# Work Order ID 95458

Item Name: Crosstube Turning Detail

<b>DART AEROSPACE LTD</b>	<b>Work Order:</b>	<b>95458</b>
<b>Description:</b> Crosstube Assembly (205/212 High Aft)	<b>Part Number:</b>	<b>D212-664-241</b>
<b>Inspection Dwg:</b> D212-664-241 <b>Rev:</b> D		<b>Page 1 of 2</b>

DRAWING NO. D212-664-241	TITLE CROSSTUBE ASSY (205/212 HI AFT)	REV. D	DART AEROSPACE LTD ENGINEERING ORDER		D.E.O. NO. D212-664-241-D-1	SHEET NO. SHEET 1 OF 2	SCALE NTS
DRAWN	CHECKED	MFG. APPR.	APPROVED	DE APPR.			
DATE 11.04.07	DATE 11.04.11	DATE 11.04.12	DATE 11/04/12	DATE 11.04.12

D212-664-241/-241B  
ASSEMBLY DETAIL

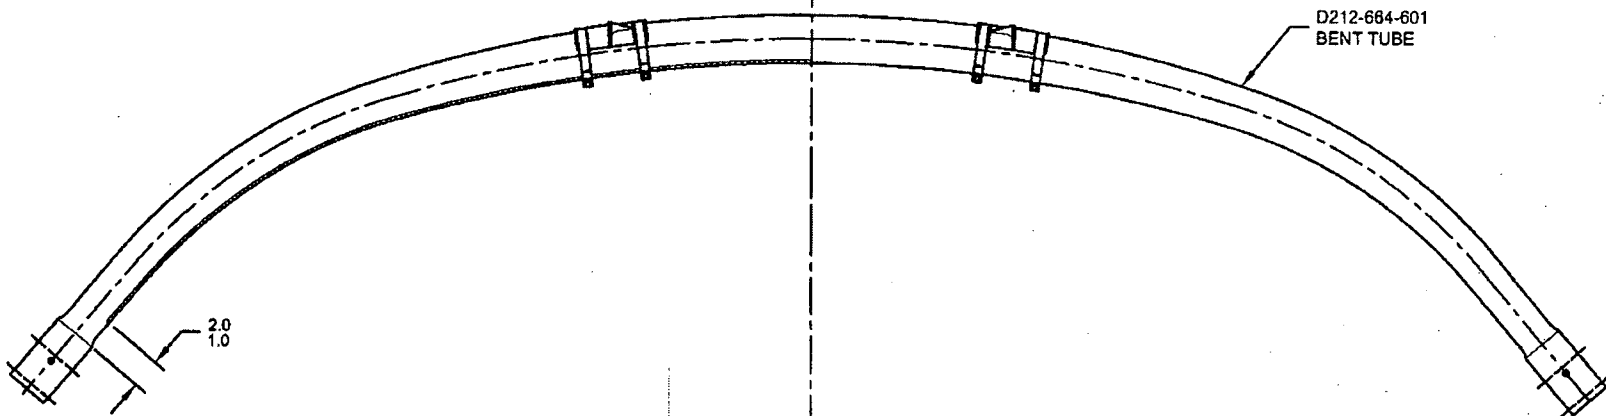
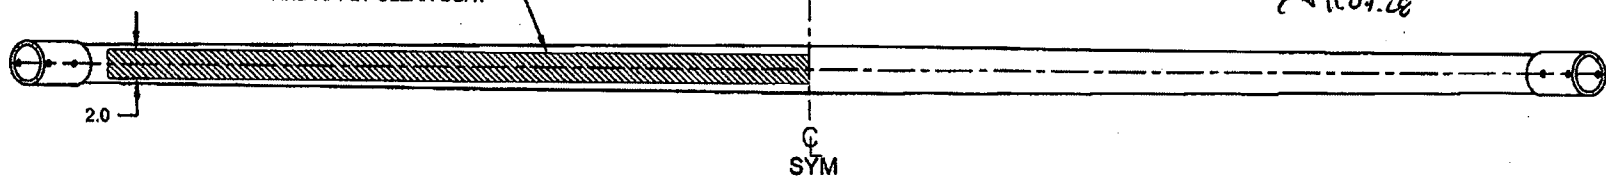
**PURPOSE:**

ADD AN INSPECTION WINDOW TO UNDERSIDE OF CROSSTUBE.

NOTES 2 OF SHEET 1 IS AMENDED AS FOLLOWS:

- 2) FINISH: CHEMICAL CONVERSION COAT PER DART QSI 005 4.1  
PRIME INSIDE AND OUTSIDE PER DART QSI 005 4.2  
MASK UNDERSIDE OF CROSSTUBE AS SHOWN (HATCHED AREA) AND  
PAINT OUTSIDE PER DART QSI 005 4.2  
REMOVE MASKING AND APPLY CLEAR COAT

MASK AREA PRIOR TO PAINTING,  
REMOVE MASKING AFTER PAINT  
AND APPLY CLEAR COAT
